ADDENDUM NUMBER (1) One
IFB-21-PW-007
POLICE DEPARTMENT PARKING LOT RECONSTRUCTION PROJECT

September 24, 2020

PS2199 RRDPS
PARKING LOT
BASE BID

SHEET
2-1

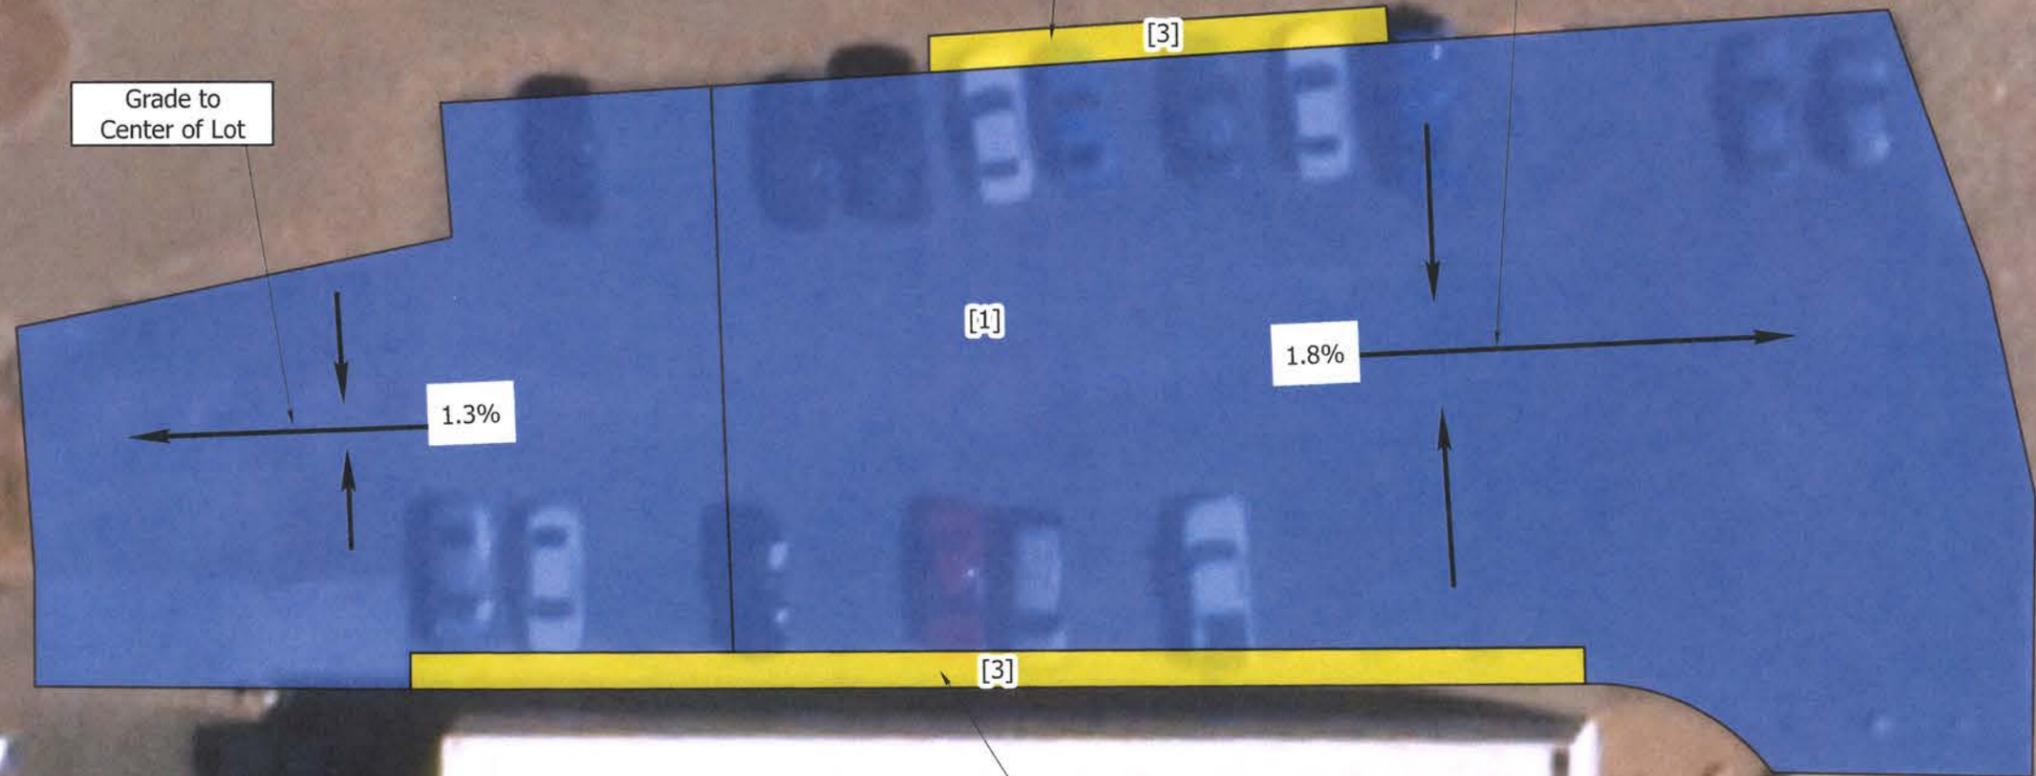
7. **Question:** *At the pre-bid meeting, it was discussed that the utility island will be removed per addendum. Will this eliminate the Drive Pad, item 608106 and replace the quantity with new asphalt paving?*
a. *Will any electrical connections be removed and capped prior or will the contractor need to subcontract with an electrical contractor to ensure the island can be safely removed?*

- Remove and replace Sheet 2-1 with the revised sheet provided. Revision includes the full removal of the Utility Island, and paving over it.
- Please remove pages 55 through 59 of the original bid form and replace with the revised Bid Form attached hereto.

Answer: Yes. See the revised bid form as part of the addendum.

- a) **The electric will be disconnected prior to construction. The water is abandoned. Contractor will be required to cap and bury the sanitary vertical stack. The contractor is required to verify or complete these items as part of the utility coordination allowance.**
